Re: SSD 8847 - Dunedoo Solar Farm – Proposed relocation of battery storage and screen planting

Attachment A	Current Project layout
Attachment B	Updated Project layout incorporating the Proposed Changes
Attachment C	Updated Project layout detailed
Attachment D	Assessment of the Proposed Changes

Attachment A Current Project layout

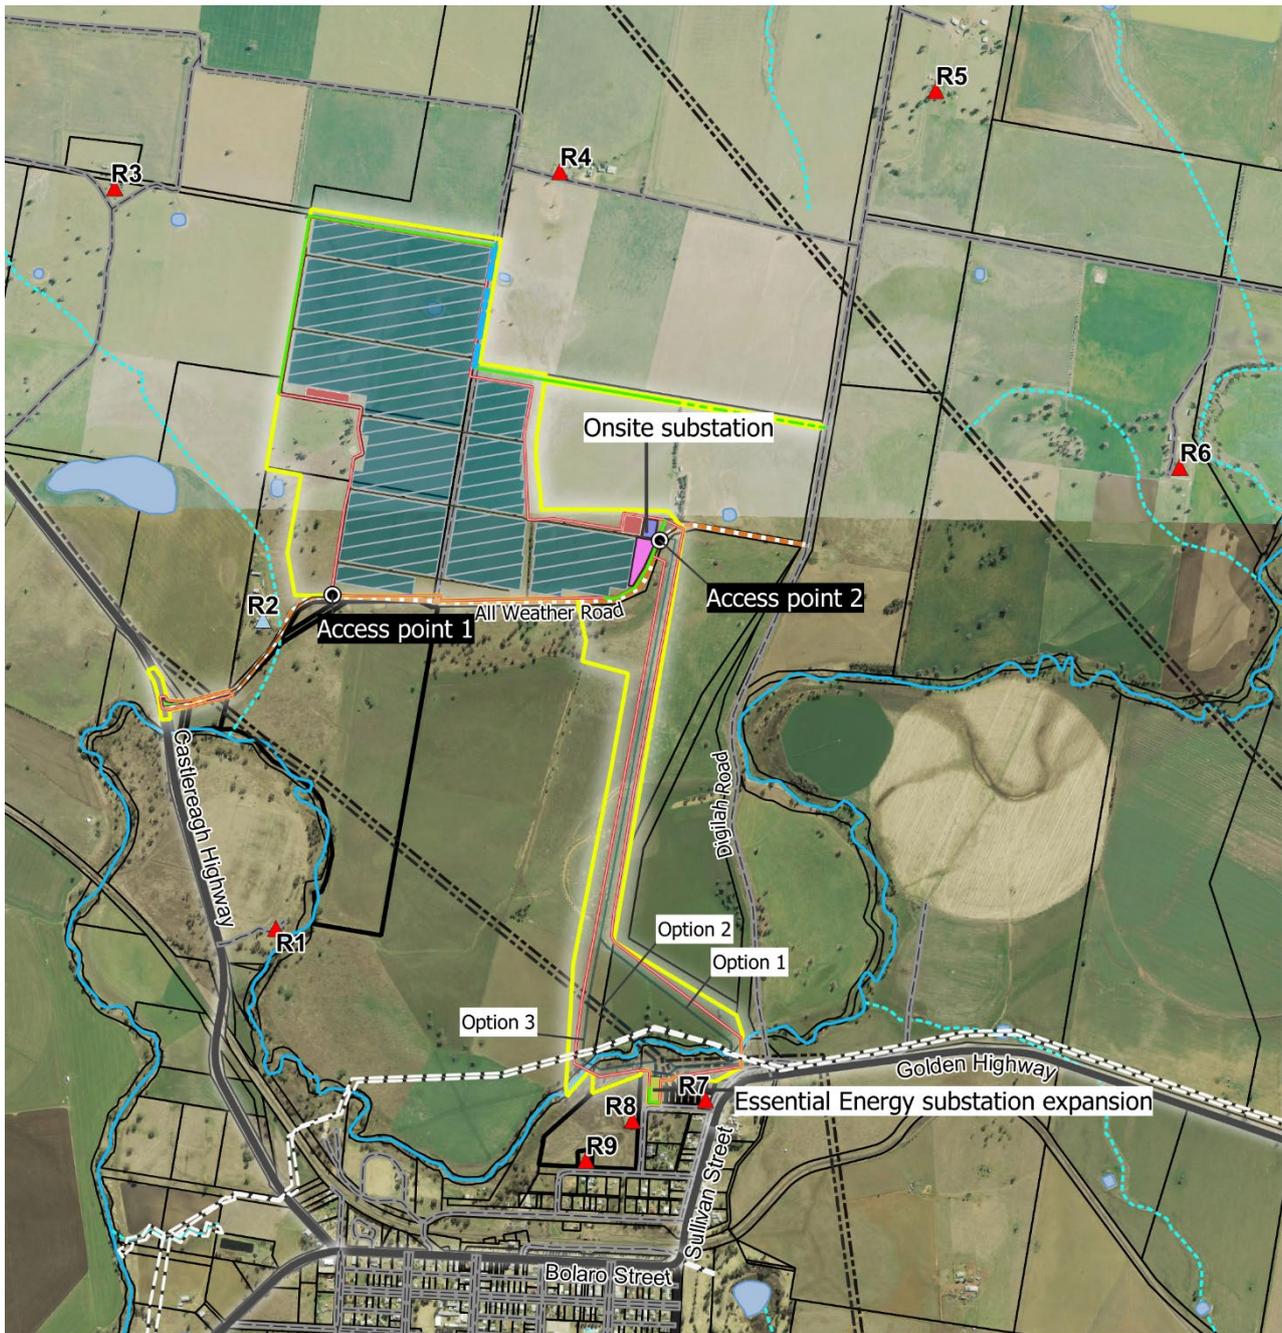
The current locations of the battery units and vegetation screening are identified in **Attachment A**. The proposed Central Battery Yard and Additional Screen Planting and corresponding minor adjustments to the extent of the solar arrays and onsite substation and site compound (collectively, the Proposed Changes) are shown in **Attachments B and C**.
